Statement

Product Name: BT&WIFI Module

Original Model Number: FC64E

Variant Model Number: FC64E-B

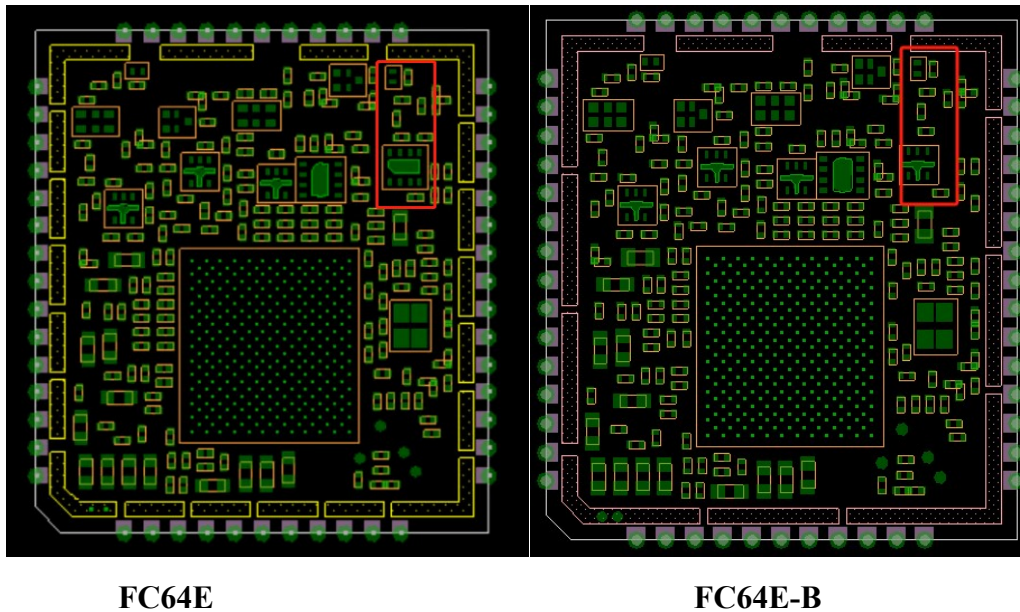
1. FC64E version is BT/WiFi0 shared antenna, FC64E-B version is BT individual antenna.

2. FC64E-B, the components in the red box will be mounted.

We hereby state that there is no any other internal difference between them and the change are mounted part of Bluetooth individual antenna which won't affect the WiFi RF portions
